AMENDMENTS TO THE DRAWINGS

The attached sheets of drawings include changes to Figures 1 and 2. These sheets replace the original sheets.

Figure 1

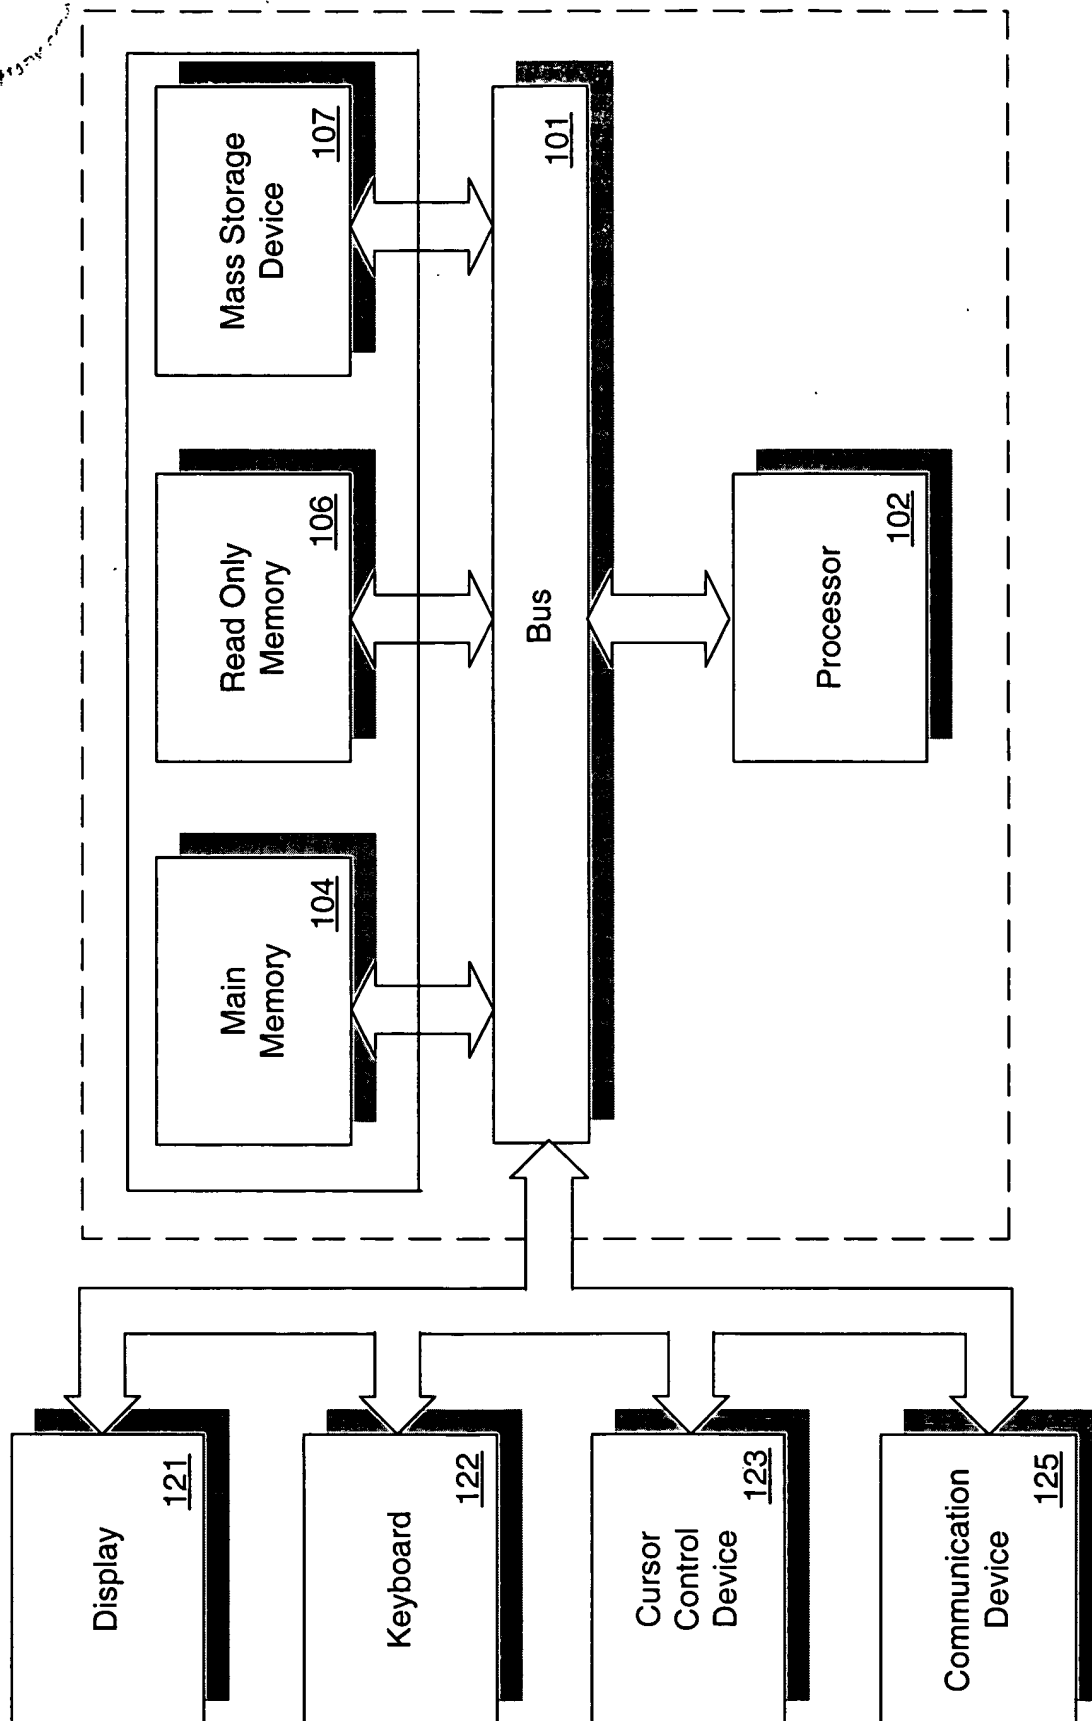
With regard to figure 1, please replace originally submitted figure 1 with the amended figure 1 submitted herewith. Amendments to figure 1 include removing item "110" and the line pointing to the item "110".

Figure 2

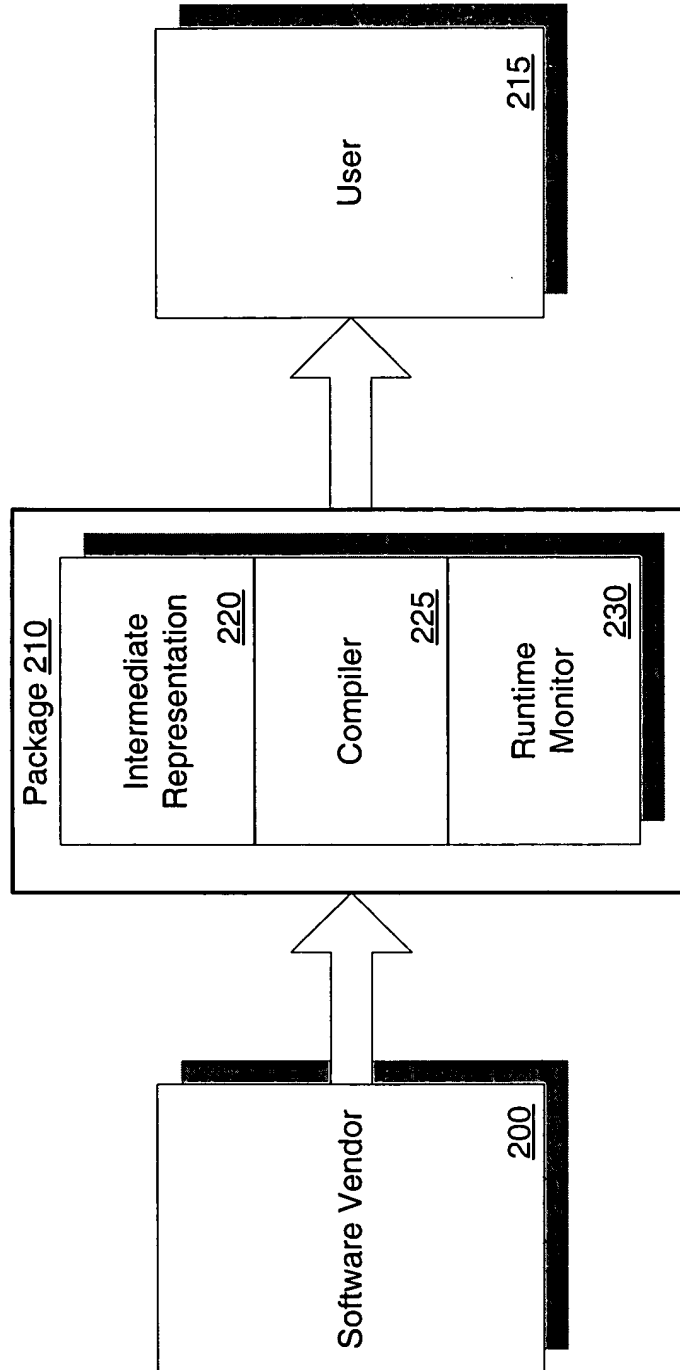
With regard to figure 2, please replace originally submitted figure 2 with the amended figure 2 submitted herewith. Amendments to figure 2 include adding "Package 210" and a rectangular box, which Package 210 represents, surrounding items 220, 225, and 230.
